Re: Approval, MRP Amendment, BLM Approved Mine Sequence Change,
Number 5 Mine, Price River Complex, Castle Gate Coal Company,
ACT/007/004, Folder #4, Carbon County, Utah

RE: Mine Sequence Change #5 Mine, Castlegate Coal Company,
ACT/007/004, Folder No. 3 and 4, Carbon County, Utah

Subject: Request for permission to seal 7th East No. 5 Mine

FIGURE 1

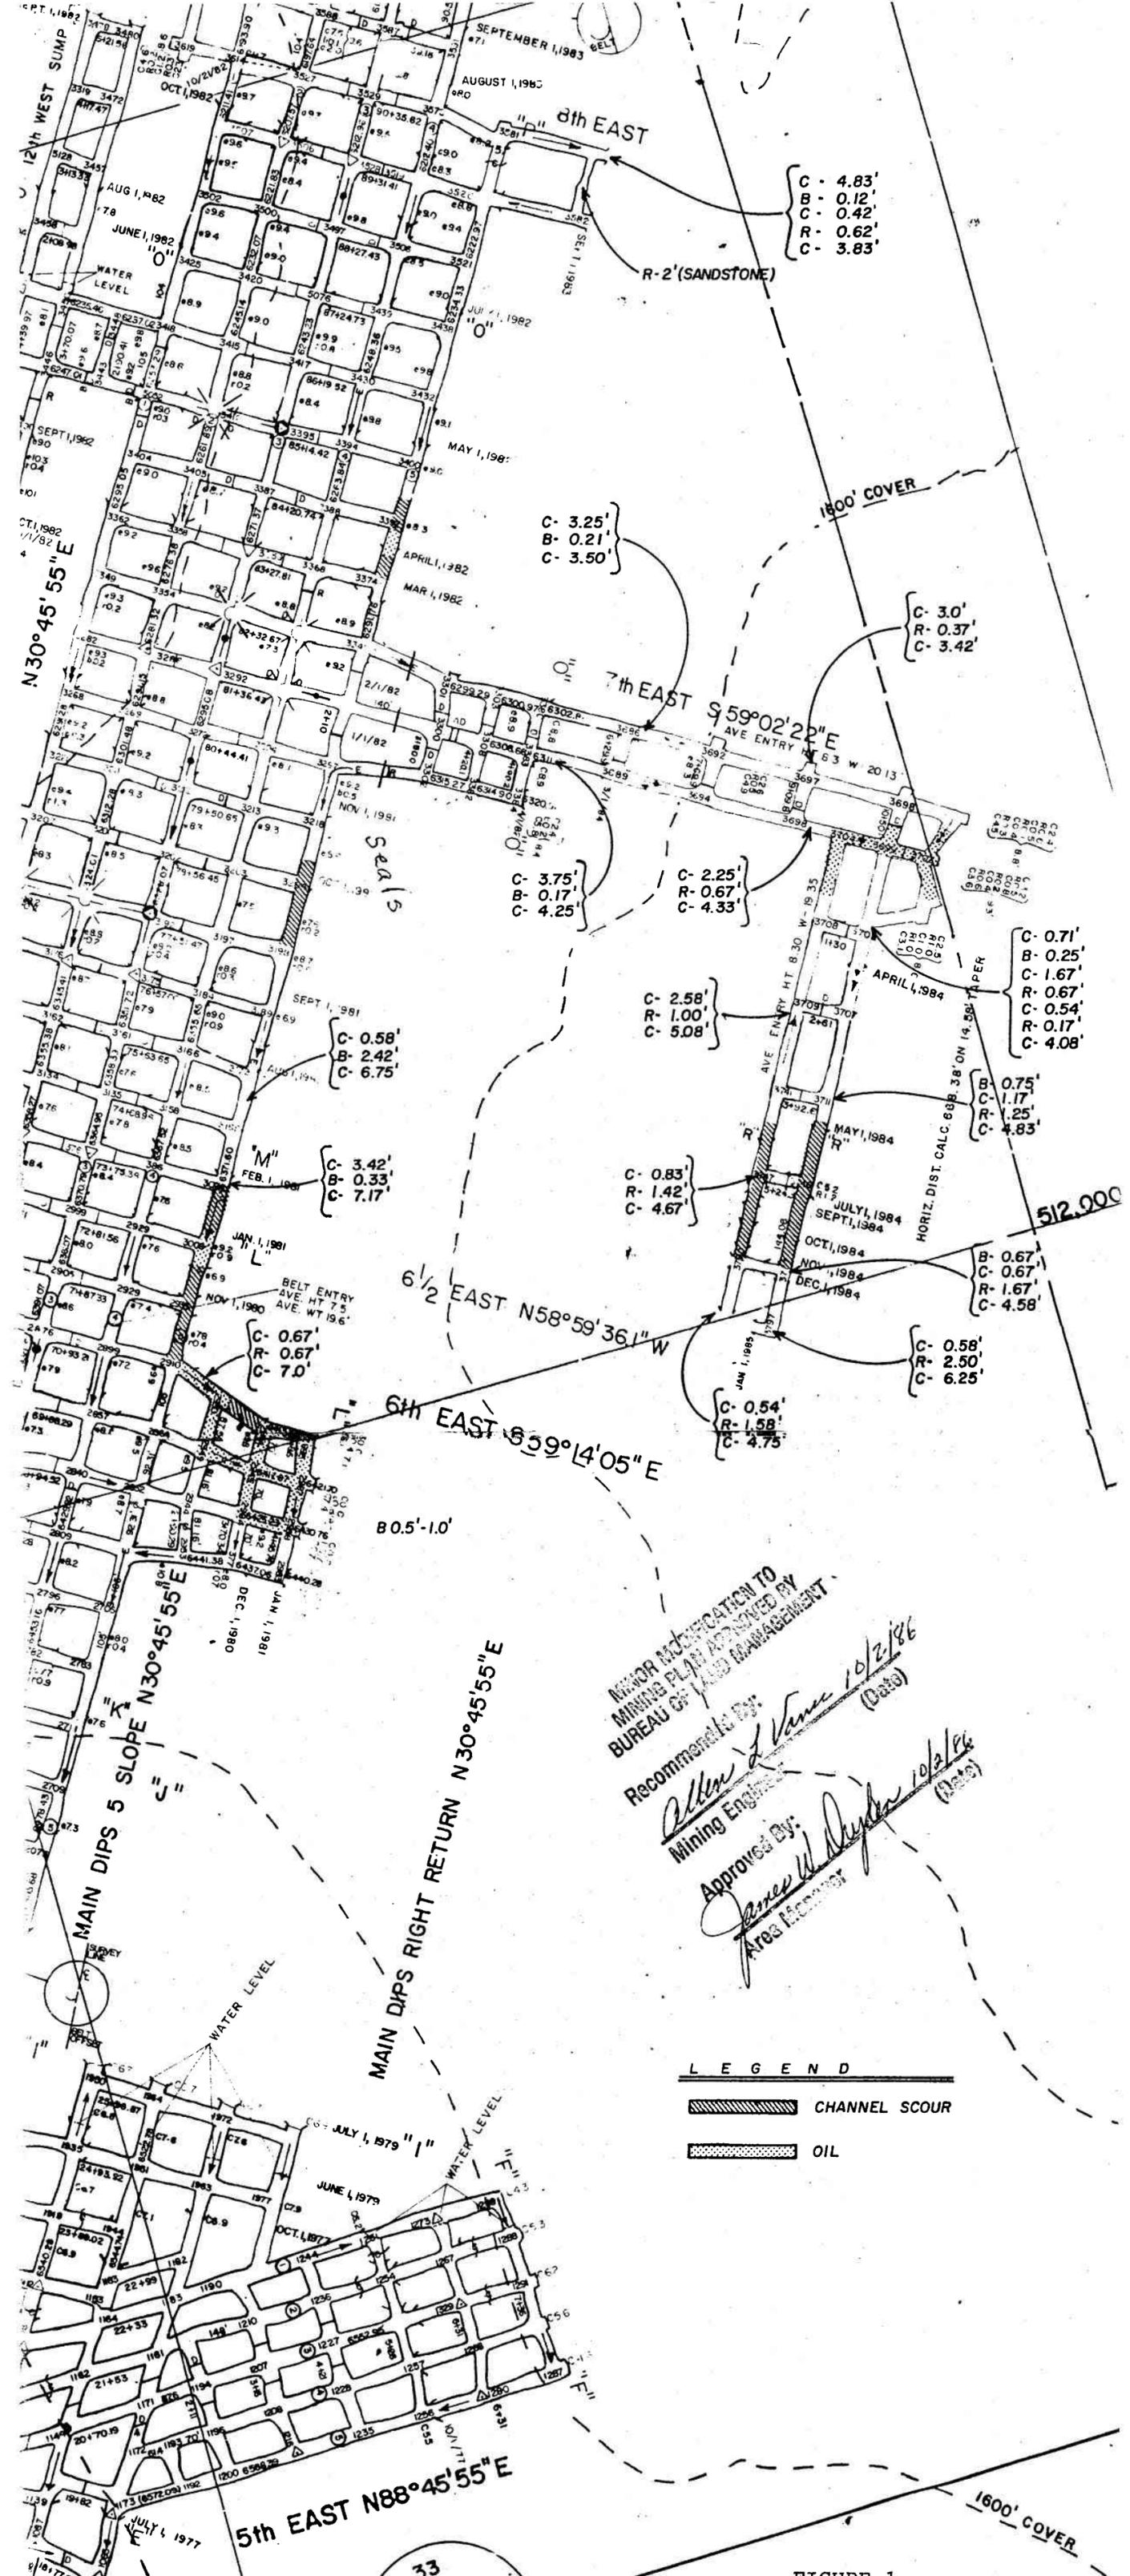
Castlegate Coal Company has shown sufficient evidence to conform to recovery and utilization of coal reserves under UMC 817.59. No other adverse conditions should develop do to sealing of the 7th east entry.

Castle Gate Coal Company has taken a close look at the reserves in the 7th East area of the No. 5 Mine and determined the area economically unmineable due to the known geologic complications in the area. (See figure 1)

The proposed plans are acceptable and approval is hereby granted to seal the Seventh East entries in order to utilize the air in other parts of the mine.

Accordingly, approval is granted to seal the Seventh East entries with permanent type seals due to the unminable conditions in order to utilize the air in other parts of the mine.
